CITY OF NEWTON
Department of Public Works
ENGINEERING DIVISION

MEMORANDUM

Re: Special Permit – 145 Warren Street

*Topographic Site Plan
Showing Proposed Conditions at
#145 Warren Street
Newton, MA
Prepared by: VTP Associates Inc.
Dated: November 4, 2020
Revised: January 20, 2021
&
Turning Radius Plan
Prepared by: VTP Associates Inc.
Dated: February 12, 2021*

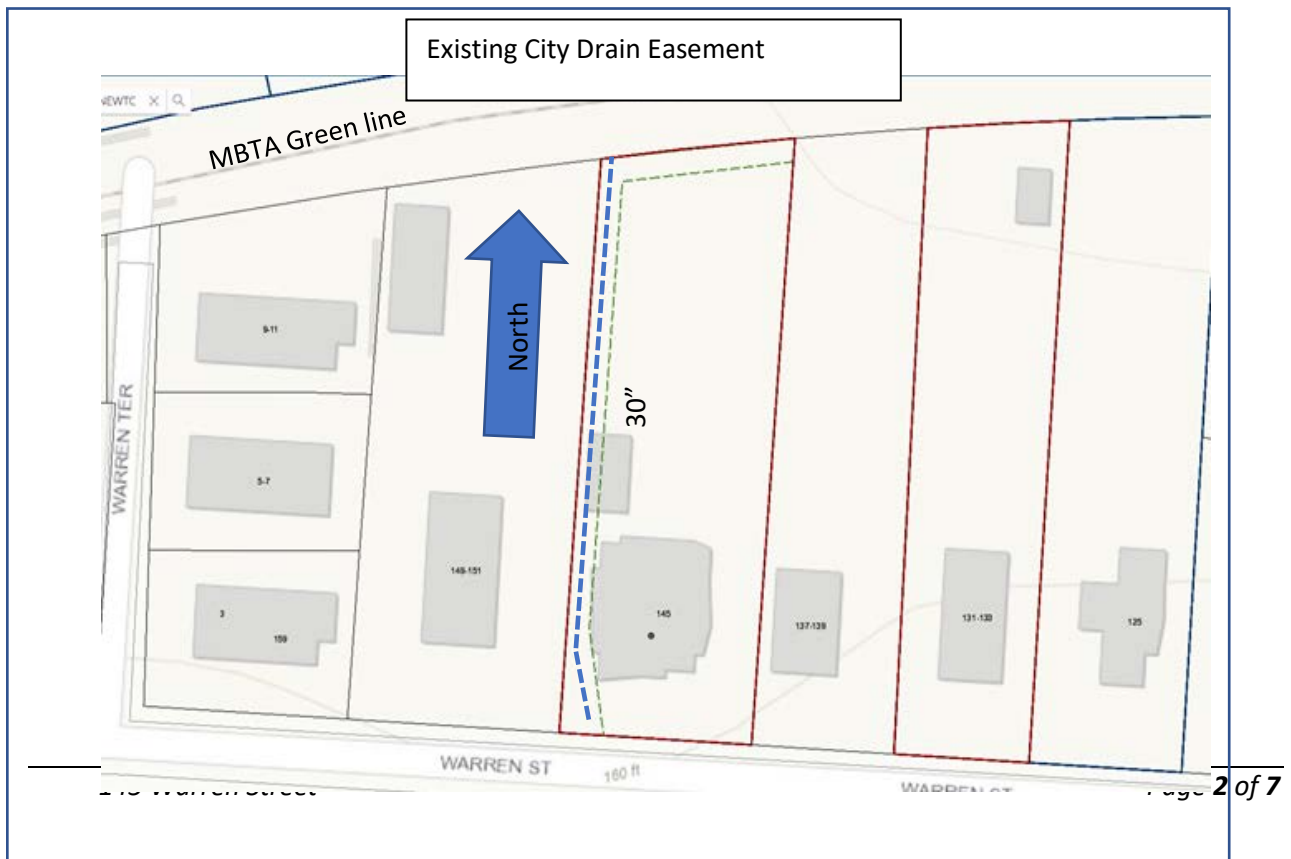
Access to the units, garages and auto court is provided via driveway located near the easterly property line. The driveway has a retaining wall near the property line for a distance of +/- 150-feet and is 6-feet at the high point. Retaining walls over 4 feet high will need a structural engineers design to ensure that the wall does not fail in (overturning, sliding or settlement) along with a safety fence along the top of the wall, detailed analysis including wall drainage and detailed grading and/or section(s), and finished surfaces will be required when applying for a Building Permit with the Inspectional Services Department.

A 10-ft. wide City drain main easement traverses the property along the north and west property lines, a 30-inch drainpipe transmits stormwater from the road collection system through the lot and into the wetlands along the MBTA. The design has a proposed retaining wall located adjacent to the drainage easement; should this application be approved; the actual position of the drainpipe must be delineated with a Closed-Circuit Television and sonic tracer to ensure that the pipe is within the easement and the construction of the proposed retaining wall and/or foundation of the proposed units do not interfere with the pipe. Post construction inspection of the 30" drainpipe via a closed-circuit television (CCTV) will also be required and should be part of any Board Order. Both CCTV inspections must be witnessed by a representative from Engineering.

The engineer of record has designed a drainage collection system consistent with the DPW Stormwater Management Policy that collects and infiltrates the 100-year storm event on site. The design includes four infiltration systems for infiltration of roof and driveway runoff. Test pit #2 indicates standing water at 28-inches (elevation 146.4) the bottom of drain system #3 is at 148.4 which provides the required 2-foot of separation; however, the test pit was conducted on January 28, 2019 it is likely that the seasonal high ground water (SHGW) during the spring season maybe higher. No dewater plan was provided, and a Construction Management plan is needed for evaluation.

System #3 is located in the rear yard, my concern with the siting of this system is the proposed location and long-term maintenance requirement. The Operations and Maintenance [O&M] plan indicates that the system needs to be inspected and cleaned, however; access to this system is difficult at best as it is placed behind the dwelling units, there is no easy access to clean the system. I recommend that this proposed infiltration system be located within the proposed auto-court for easier access. Additionally, system #4 has an overflow that will discharge to the wetlands along the MBTA, this overflow should be eliminated if this system is adjusted. The O&M plan does not include any provisions for bi-annual sweeping of the driveway and auto court, this is needed as it impacts the long-term performance of the infiltration systems.

The turning template plan indicates a 2010 BMW 5 Series making maneuvers into and out of various parking stalls, my issue is will the development have a restriction on the type of vehicle that can be accommodated? Different types of vehicles should be study such as a minivan, or SUV. Additionally, on sheets 2 and 3 the BMW is shown making the turns, however; it encroaches into the neighboring stalls that are empty. The plan should be updated to show the other stalls occupied and with various size vehicles then show updated turning movements for various size vehicles.
